DDM Updates & Scheduling

Drainage Stakeholders Meeting

June 26, 2013

Curb and Gutter Section

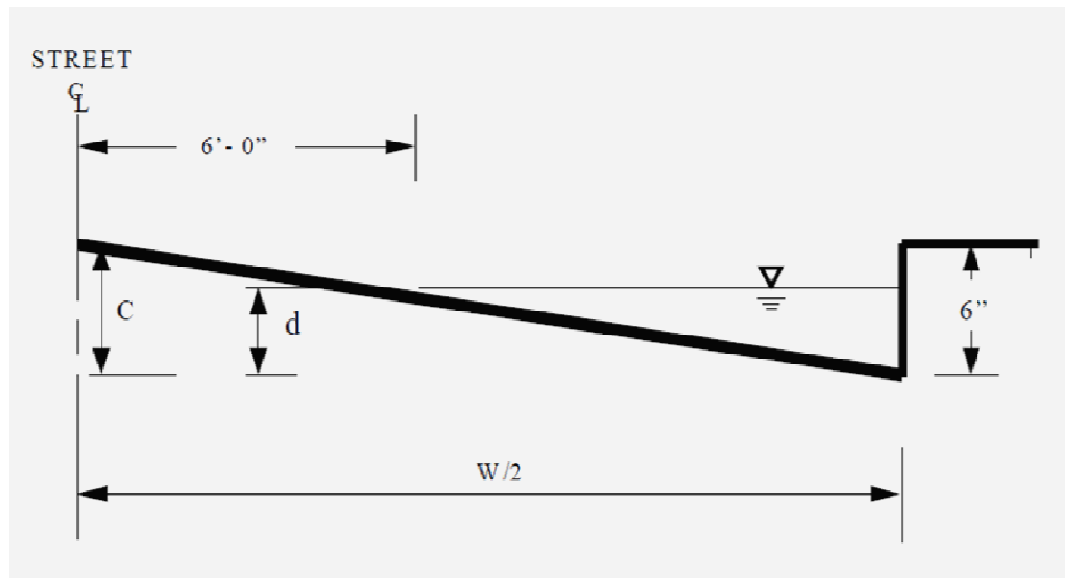
- Section 1.2.3: Reported that when the cross slope is less than 2% that trying to achieve a crown elevation no lower than 2-inches below the top of curb is hard to obtain.
- Section 1.2.6.D.3: Fence requirement based on depth not included
- Section 1.2.7: Requirement for evaluation of impact to upstream areas not included
- Section 1.2.9: Need clarification as to when LOMR is required, what calculations to submit, and application to ETJ areas
